Access Compliance Report

Public Rights-of-Way

(Curb Ramps)

Intersection ID: 48644	Main Street: SOCATA_WY	Cross Street: ROCKY_FORD_CLUB_RD	Location: E
ADA ID: 3378135B1DAB	Ramp Type: Combination1	Initial Pass/Fail: Fail	Overall Compliance: No
		Severity Score: 35

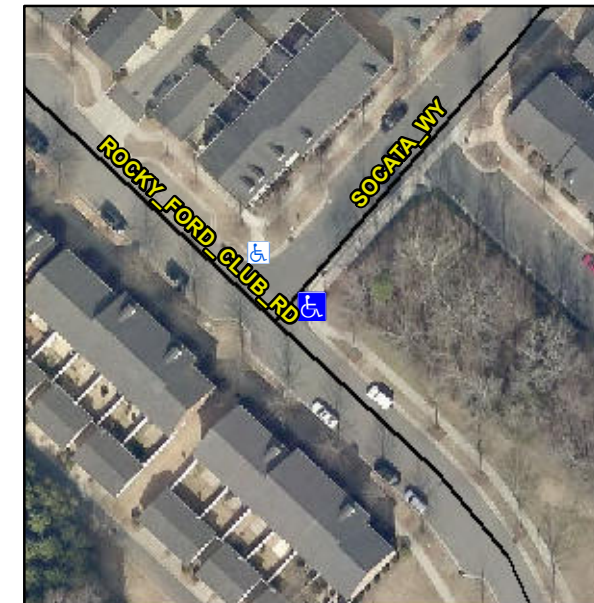
RT RP < 5%

R304.5.1, R304.5.3, R304.3.2

Remove & Replace Entire Ramp.
